**Amendments to the Drawings:**

## REMARKS/ARGUMENTS

FIG. 5

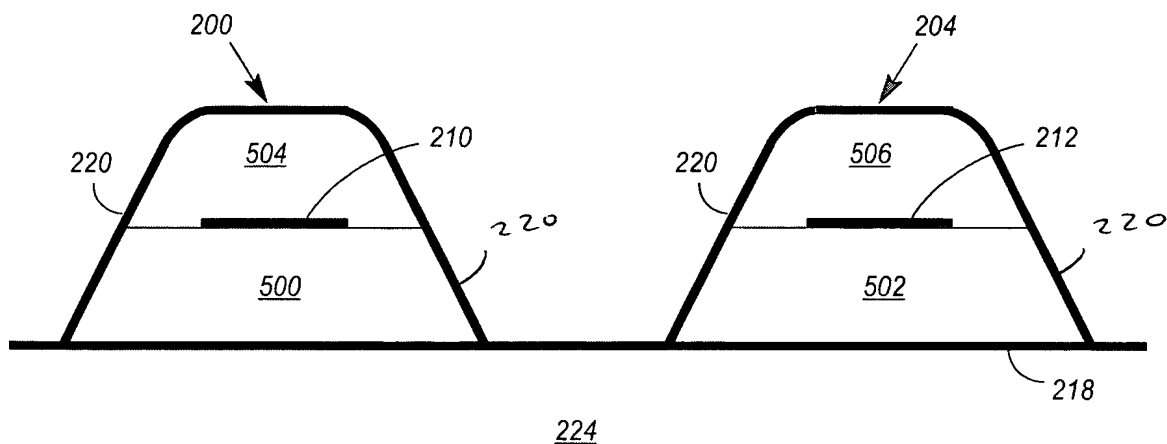
The attached sheet of drawings includes changes to FIGS. 5 & 6. This sheet, which includes FIGS. 5 & 6, replaces the original sheet including FIGS. 5 & 6. In each of FIGS. 5 & 6, the reference number "220" has been repeated in additional places to more clearly indicate the extent of the "ground shield 220" in each figure.

The Examiner objects to FIGS. 5 & 6 of the drawings because reference number "220" does not appear on the right-hand sides of the ground shields 220. Applicants have amended the drawings to include these additional references to ground shields 220. Applicants do not believe their amendments add new matter.
